**Italian American Sportsman's Club – 2275 Kuser Road, Hamilton Township, Mercer Co. New Jersey
(Block and Lot Map 231, Section 2575, Lot 47.01 and NJDEP PI No. 552707)**

Hamilton Township Council Meeting – October 15, 2013

Public Comment to The ELM Group RIRA/RAW dated May 24, 2013

PROJECT : ITALIAN AMERICAN SPORTSMAN CLUB HAMILTON TOWNSHIP, NEW JERSEY		
DESCRIPTION : FIGURE 1 GENERALIZED SITE PLAN SHOWING SHOTFALL ZONES		
DRAWN BY :	RC	SCALE : 1"=50'
CHECKED BY :	MM	DATE : 10/11/13
	REVISION :	PROJECT # 13315

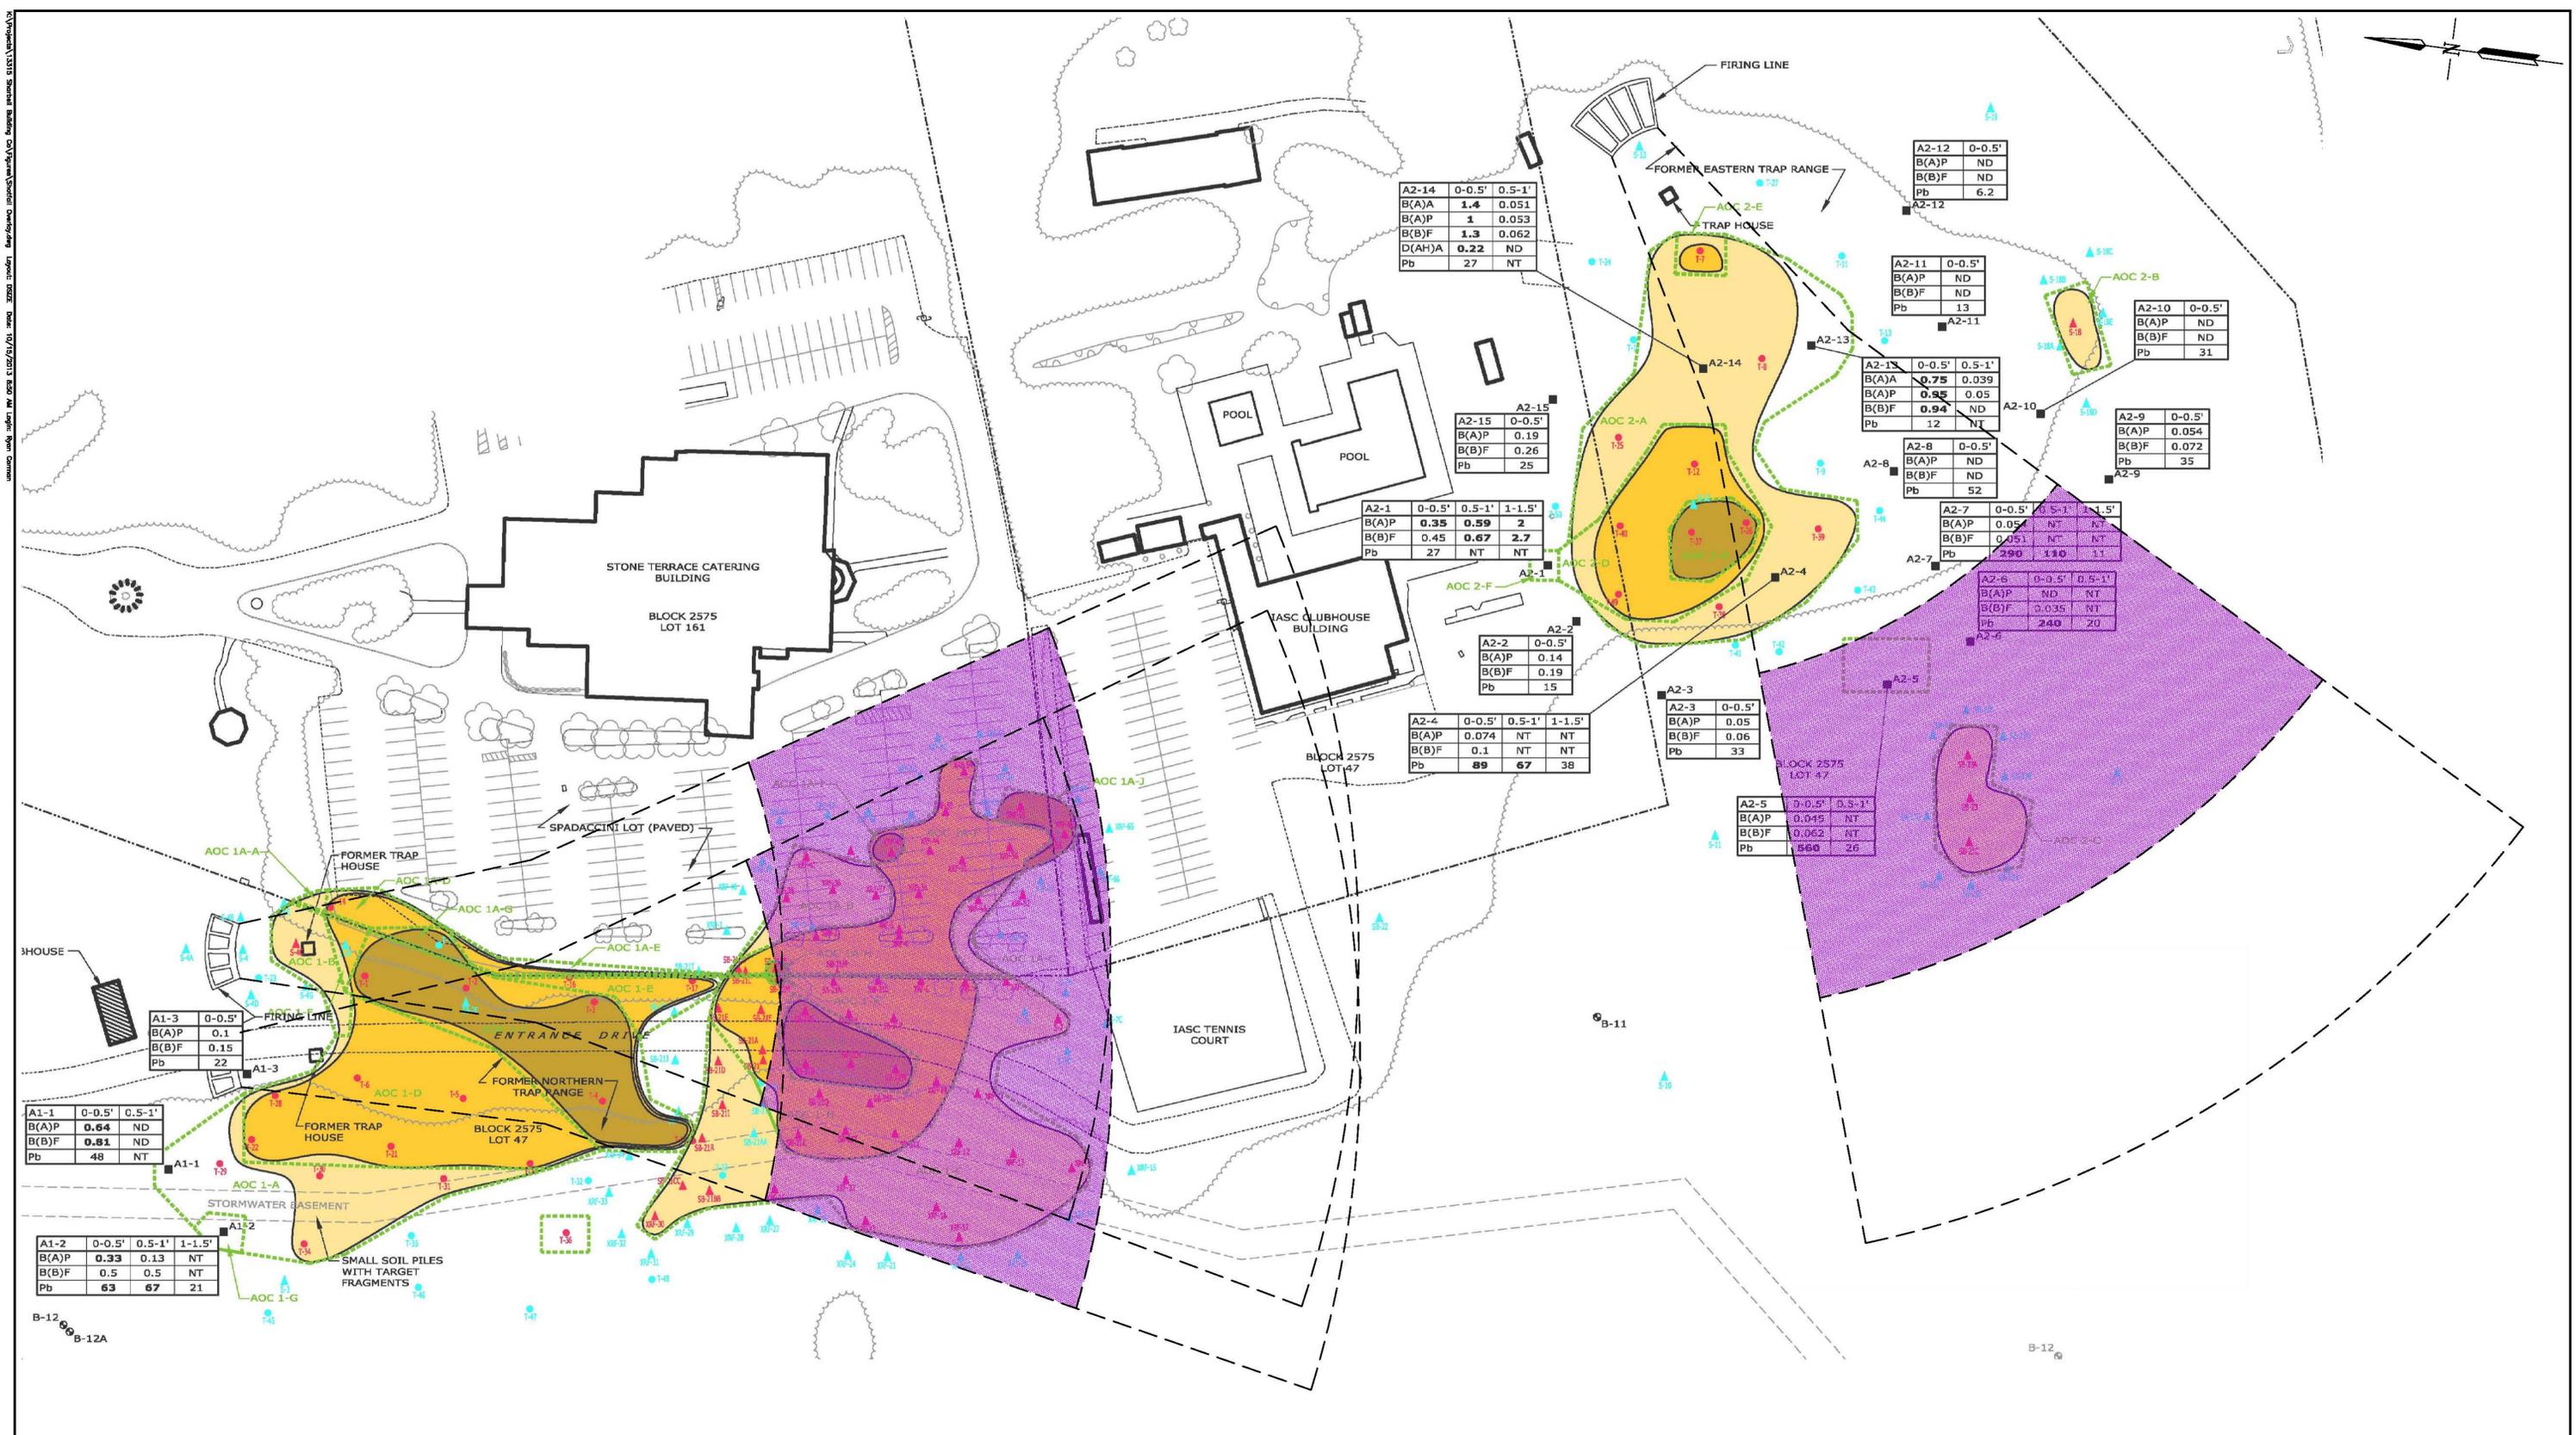
- Although requested by the Township and their consultant, Sadat, shotfall zones for the northern and eastern ranges were never accurately depicted on an aerial or detailed survey plan per the ITRC guidance, therefore the initial and subsequent delineation sample locations did not strictly conform to these zones (please refer to Figures 1 and 2).
